**Re:** December 2, 2020 Agenda: Docket items #202-00197, Request for complete demolition at 450 S. Patrick Street, 900 Wolfe Street and 431 S. Columbus Street; #2020-00196, Request for concept review at 450 S. Patrick Street, 900 Wolfe Street and 431 S. Columbus Street.

**Heritage Project - Block 1 - S. Alfred Street - BAR Hearings 7/15/2020, 9/2/2020, 10/21/20 & 12/2/20**

To: Members of the Board of Architecture Review  
From: Ellen Mosher  
Date: 12/2/20  
Re: 12/2/20 Hearing - DOCKET ITEM #4 - BAR #2020-00196 OHAD  
Concept IV review at 450 South Patrick St, 900 Wolfe St & 431 South Columbus St.

**BLOCK 2 - SOUTH ELEVATION - WILKES ST. PARK (CURRENT)**

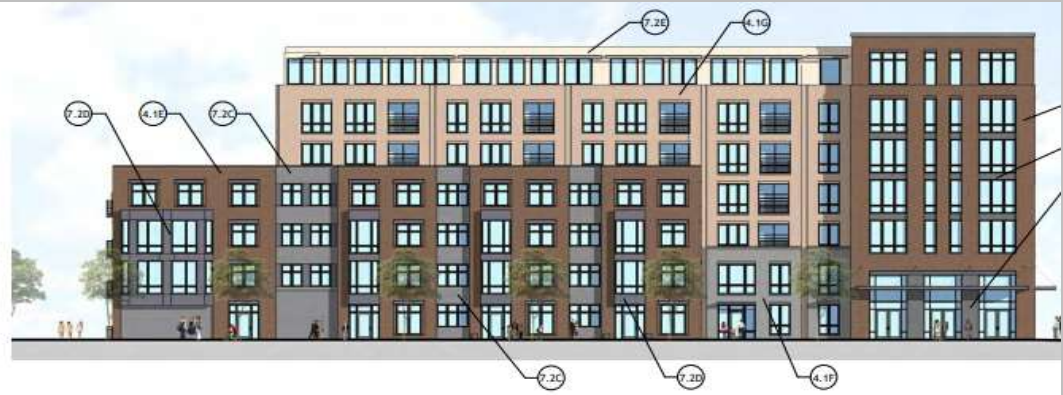
**Block 2 - Southwest corner**

Ms. Irwin felt that the revised design for the southwest corner is too fussy and preferred the previous design. She was comfortable with the height and mass but would like to see a design that is an evolution of the previous design.

Mr. Spencer agrees that he preferred the previous design for the corner to the revised version. The main building entry appears to be too monumental. He stated that a five story massing would be better for this portion of the site but that with some design changes, the proposed height could be acceptable.

Mr. Adams stated that the building is too tall and should be limited to four or five floors. He would like to see the character for the building be more contextual and include a variety of different window types and additional articulation. He appreciated the inclusion of the cornice as an element in reference to existing buildings within the historic district.

Ms. Neihardt stated that she prefers this revised design to the one previously submitted and agreed with Mr. Adams regarding the inclusion of the cornice.

Ms. Sennott was comfortable with the revised design but would like to see revisions to make it less symmetrical.

Mr. Sprinkle stated that the building as designed is too big and too tall. He would like to see a greater diversity of details including windows, roof line, etc. In order to improve the design he encouraged the use of additional detailing.

Ms. Roberts like the full height glass corner as a design element and likes the precast entry surround as a formal element. Similar to other parts of the building she does not support the use of projecting balconies or applied cornices. The height in this location was acceptable.

**BLOCK 2 - WEST ELEVATION - S. ALFRED ST. (CURRENT)**

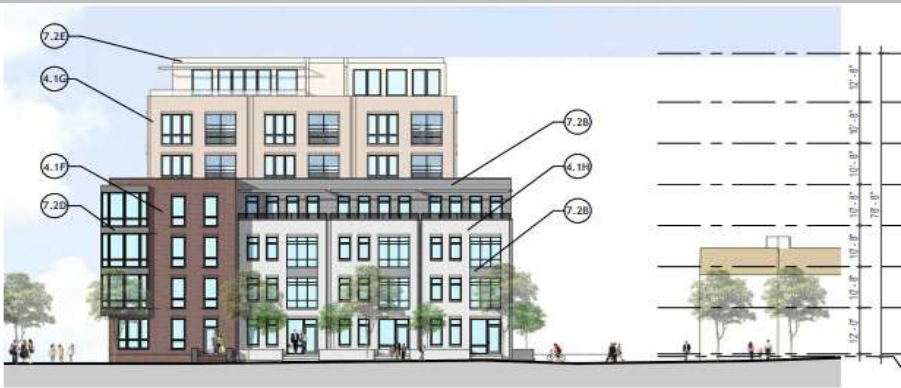
**Block 2 – Northwest corner**

Ms. Irwin preferred the revised version with the lower massing and more formal townhouse design, she found the previous design to be too busy. The brick detailing at the window openings in the revised design helps to improve the scale of the building.

Mr. Spencer was supportive of the revised design and the architectural character, he felt that the slots between the townhouse elements were too small and there should be greater differentiation between the parts of the building. The design for the garage entrance with the elimination of the projecting metal bay was more successful but he did not like the metal fourth floor at the north end.

Mr. Adams preferred the previous design for the townhouse elements.

Ms. Neihardt stated that this elevation is too plain and would prefer greater articulation. This massing could be acceptable since the project is still in the concept phase.

Christine Sennott was supportive of the direction for the proposed design and would like to see further development.

Mr. Sprinkle stated that the proportions for the townhouse elements was not correct and believed that the building is too large. He agreed with previous comments regarding the metal at the fourth floor at the north end of the building.

Ms. Roberts felt that the design for the townhouses was too plain and would like to see greater articulation as these elements continue to develop. This approach can be successful with greater evolution in the design.

**BLOCK 2 - EAST ELEVATION - COLUMBUS ST. (09.02.2020 HEARING)**

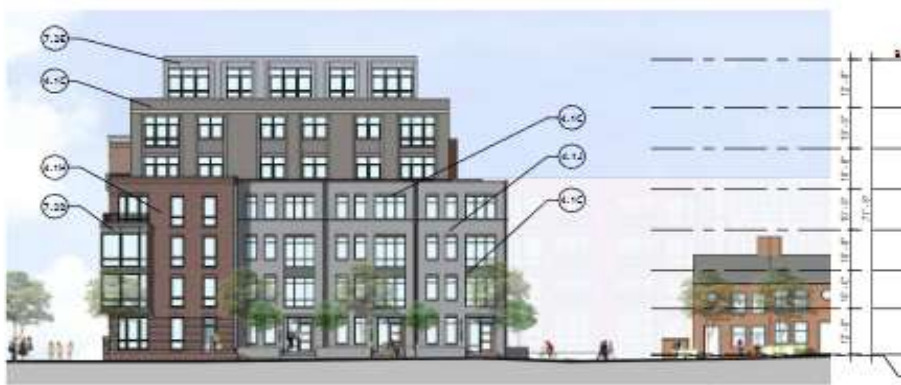
**Block 2 - Southeast corner**

Ms. Irwin prefers the previous version of the south elevation facing Wilkes Street Park that included a lower scale building massing on the backdrop of the larger massing. The east elevation has become too stark from the previous versions that included the projecting bay.

Mr. Spencer agreed that the previous version of the Wilkes Street Park elevation was more successful but stated that the lower portion could be an additional story. The applied metal bay at the corner is not compatible with the rest of the design. He agreed with Ms. Irwin regarding the level of detail on the revised design for the east elevation.

Mr. Adams also agreed that the previous design for the south elevation facing Wilkes Street Park was more successful. He stated that the overall height of the building is too tall and should be brought down by one floor and that the building was generally too large. The slots in the building at the east elevation are reminiscent of slots which were used for downspouts on historic buildings.

Ms. Neihardt agreed with the comments from Mr. Adams.

Ms. Sennott also agreed with the comments from Mr. Adams.

Mr. Sprinkle stated that the building is overwhelming for the location and should be reduced in size and height.

Ms. Roberts stated that the previous design for the east elevation which included a four story block with projecting bays was more successful than the current design which is more stark.

Table 1: Development Summary Table

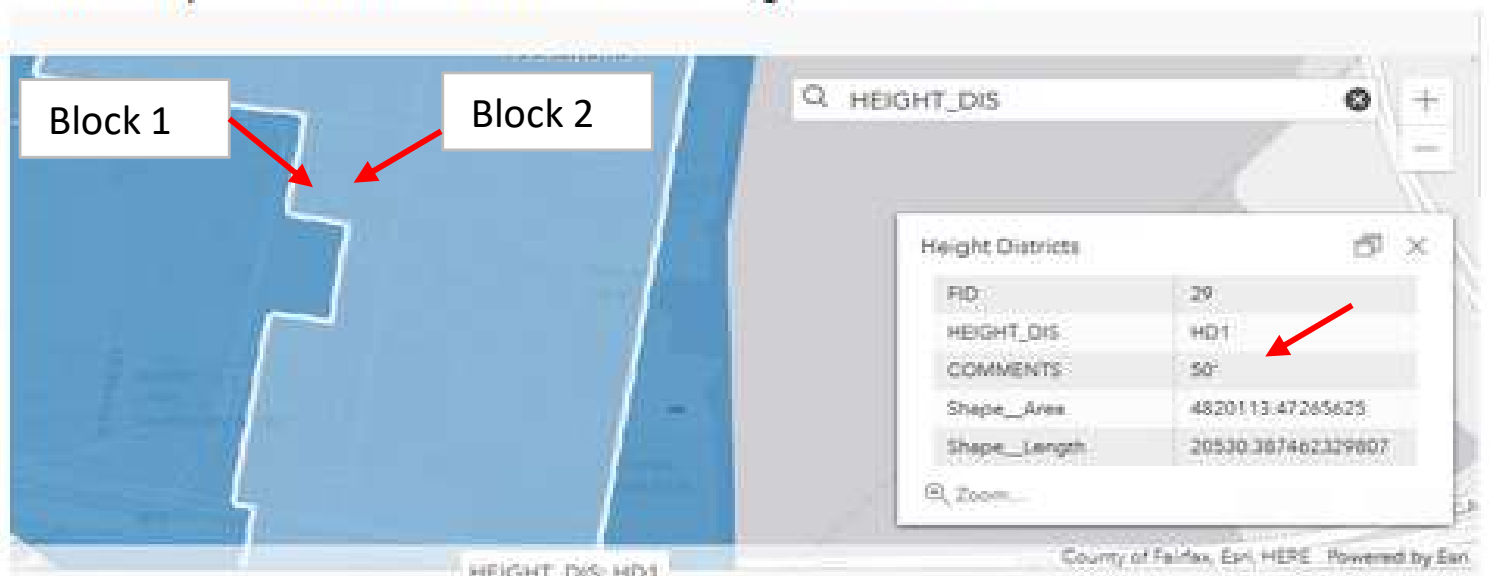
Per Table 1 in the S. Patrick St. Strategy, the recommended Block 2 building height limit is 55 feet. The existing building is 62 feet however the height limit for the new building is 55 feet not 80 feet as shown in Concept IV. *See Exhibit B.*

Applying Section 7-700 is subject to compliance with the Strategy's recommendations and ensuring that the building scale is compatible with the neighborhood and with the intent of the Strategy. This building scale is not compatible with the 2-story townhouses on the same block and in the neighborhood, and it does not comply with the Strategy's recommendations or the intent of the Strategy. *See Exhibit B.*

## Missing Height Transitions

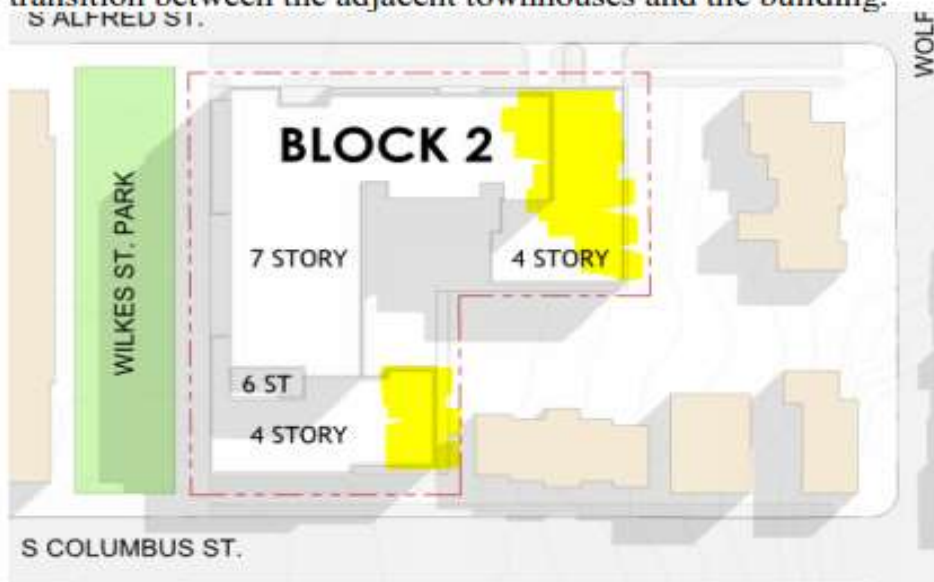
Per Staff's comments to the applicant 2/3/20 and per the S. Patrick St. Strategy, building height transitions need to be added to Block 2 on S. Alfred and S. Columbus Streets. *See Exhibit D.*

Per February 3, 2020, Staff Review Comments on Concept I

23. Block 2 comments:

- a. Provide two-to-three-story portions at the northern ends of the building to create a transition between the adjacent townhouses and the building.
